STATE OF NORTH CAROLINA
DEPARTMENT OF TRANSPORTATION

Addendum No. 1
RE: Contract # C204039
WBS # 34243.3.2
STATE FUNDED
Polk County (I-4729A)
I-26/US-74/NC-108 Interchange Modifications in the Town Of Columbus

September 19, 2017 Letting

The following revisions have been made to the Roadway plans:

17-AUG-2017 10:14
J:\I-4729A\Roadway\XSC\I-4729A_Rdy_xpl.dgn
$$$$USERNAME$$$$

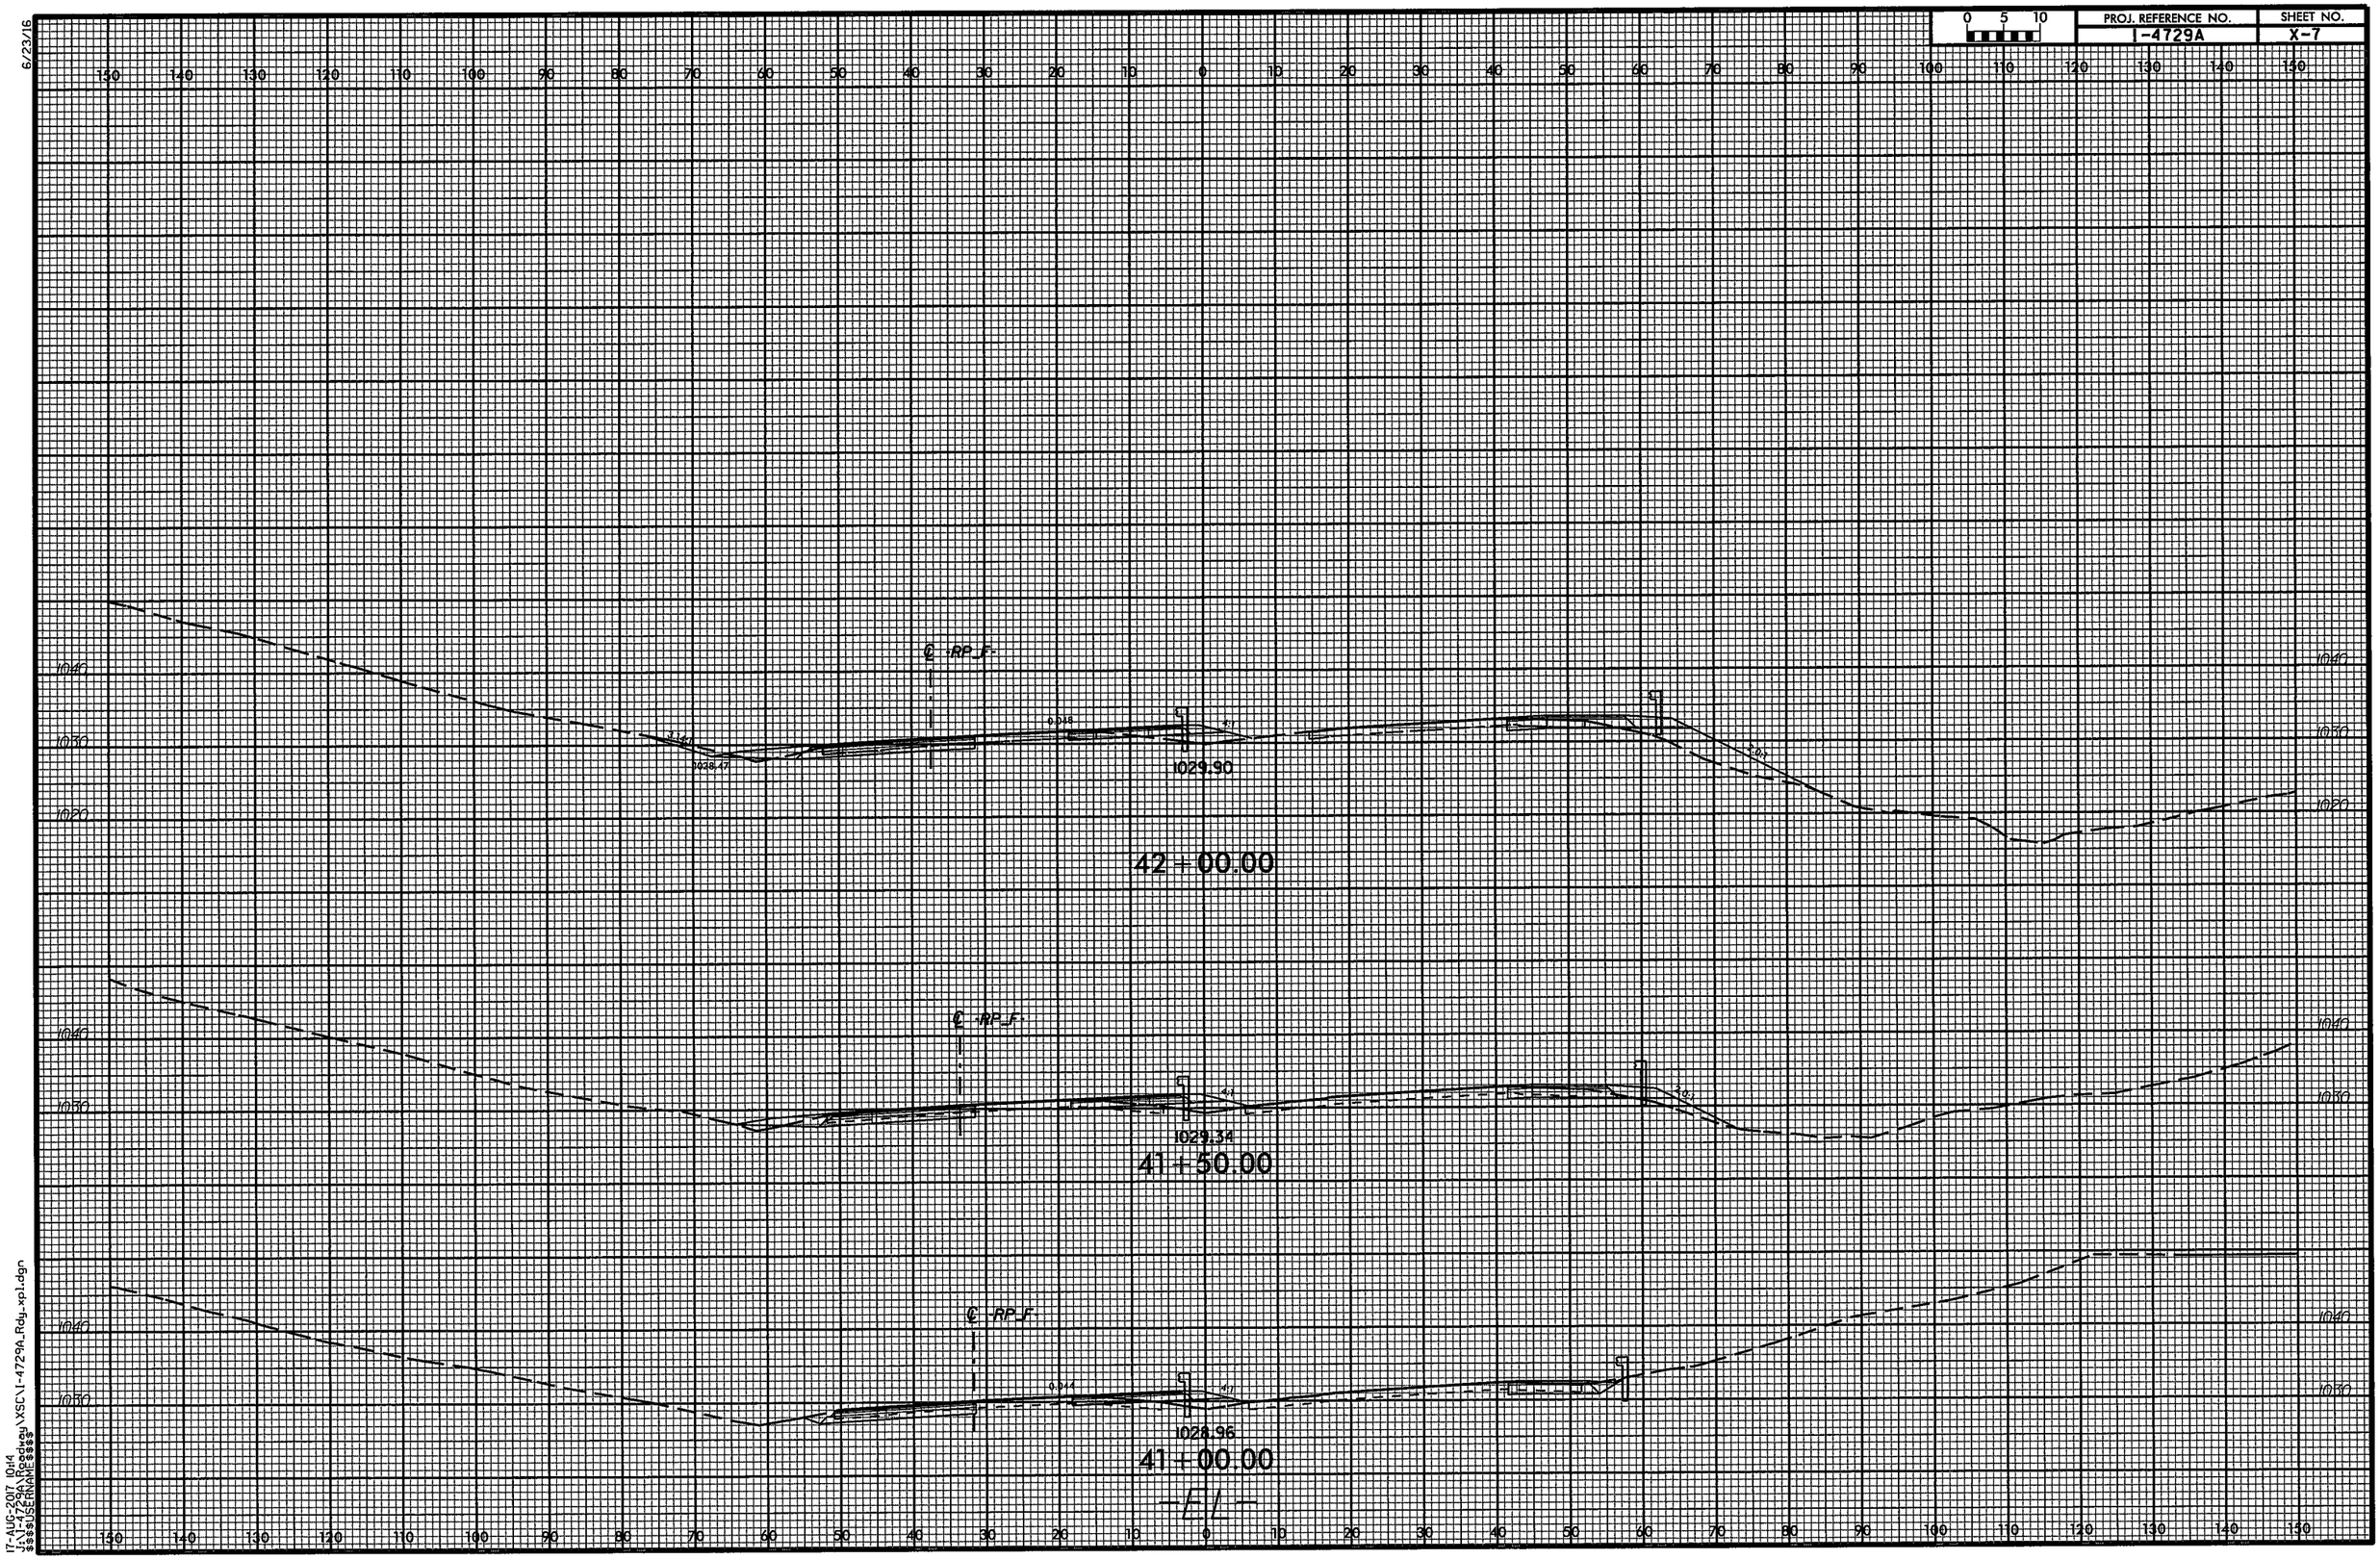
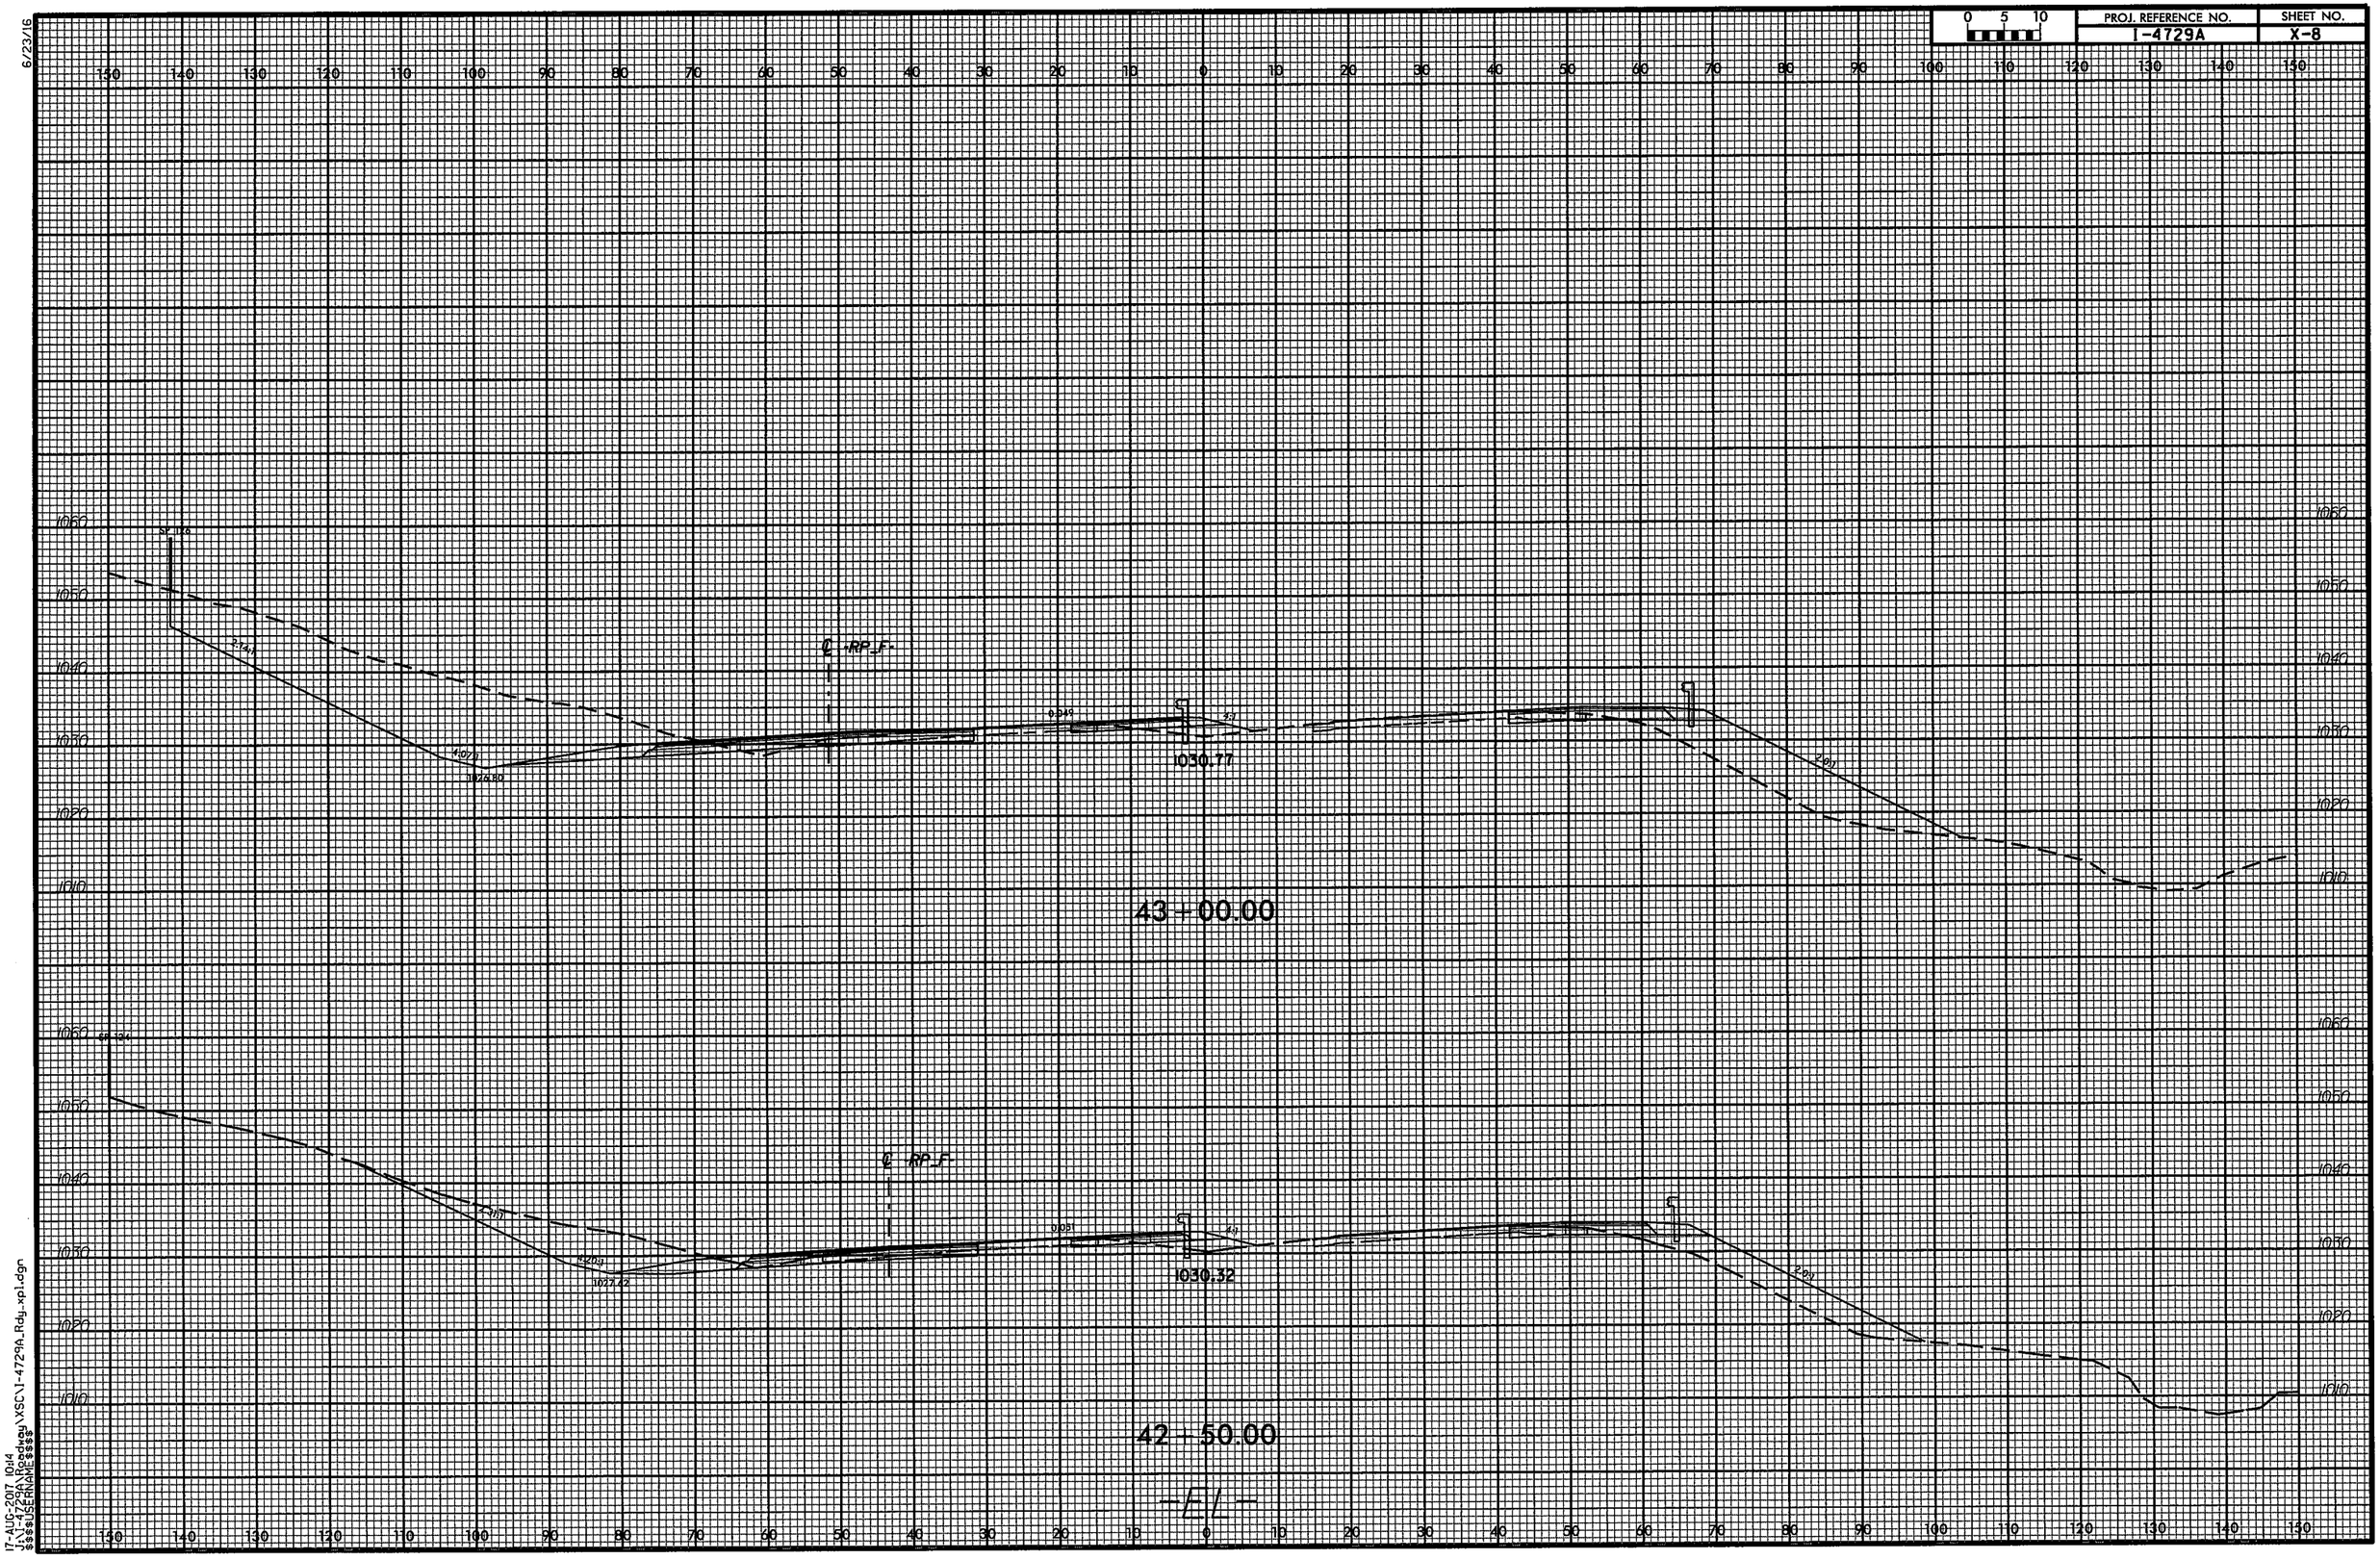
Sheet No.	Revisions
1A	Revised Index of Sheets to remove 2G-2 "Standard Embankment Monitoring Detail" and revise the number of" Drainage Summaries" sheets
2A-1, 2A-4 and 2A-5	Revised the Typical Sections for the change in mainline pavement widening design from ABC to Asphalt Base
3B-1	Revised 'Summary of Earthwork' to account for pavement widening design change
3D-1 thru 3D-4	Various drainage quantity changes as noted below
3G-1	Removed "Settlement Gauge Summary" and added note that Bridge Waiting Period only applies to Approach Slab construction
5	Revised to require Welded Steel Pipe by Trenchless method under the Interstate 26
X-1A thru X-87	Revised Cross-Sections to reflect the change in Earthwork due to the pavement design change
